DWG. NO. L1571 REV. 3

TITLE FOOT PRINTS FOR BOLT TOGETHER UNITS				TOLERANCES UNLESS OTHERWISE NOTED 2 DEC. PLACES ± .01 3 DEC. PLACES ± .005 ANGLES 1/4°				 METAL FABRICATION 1000 W. 10th St. VICTORIA, B.C. V8W 2G4	
DRAWN BY ME	DATE 12-23-97	DESIGNED BY JJ	SCALE NTS	1/4" = 1"	SH. 1 OF 1	DWG. NO. L1571	REV. 3

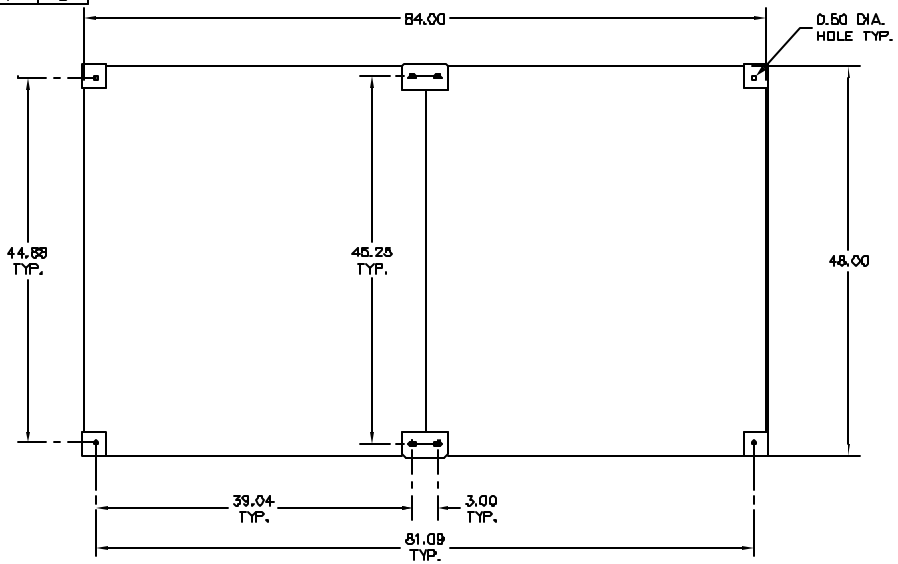
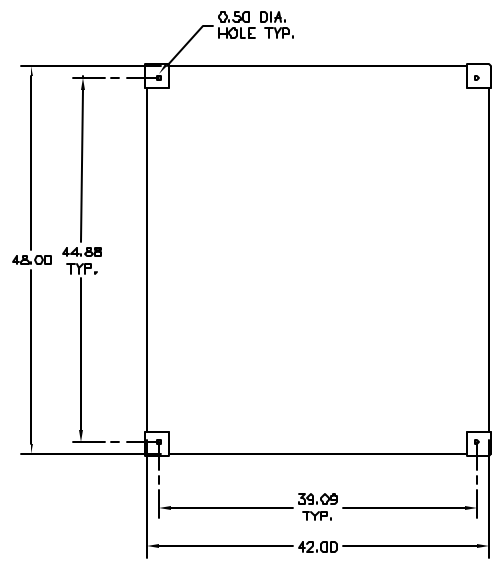
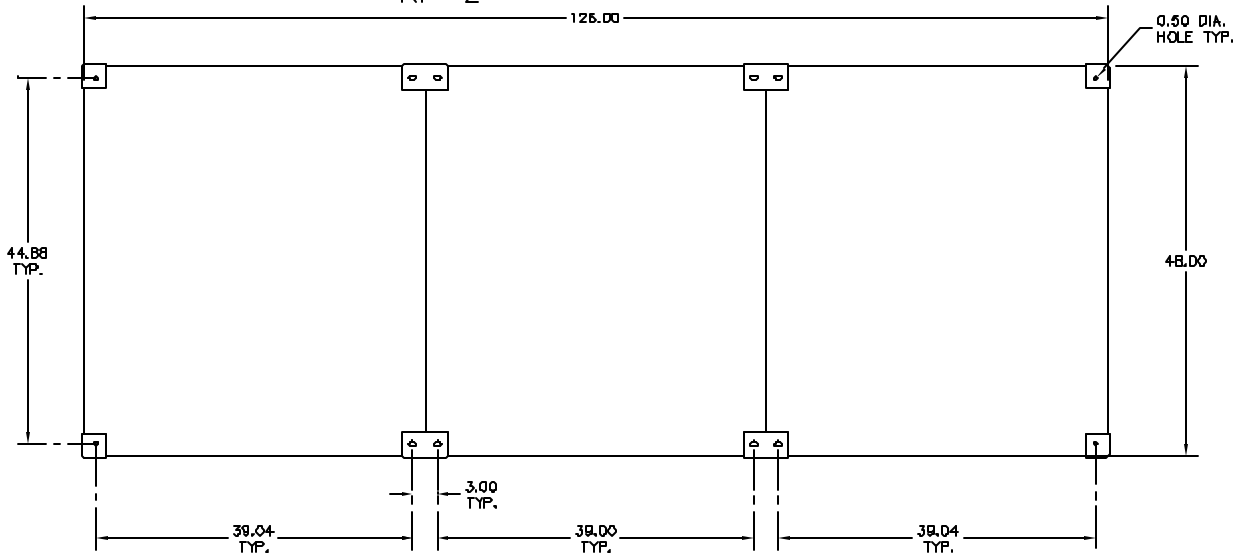
REVISIONS		
2	17-20-98	MC (EDR 9690)
CHG. TO NEW LEGS. CHG. DIM'S: 45.40 WAS 38.00; 39.30 WAS 33.50; 81.60 WAS 88.00; 39.00 WAS 35.00.

3	8-25-98	MC (EDR 8132)
CHG. LEG HOLE PLACEMENT DIM'S CHG.
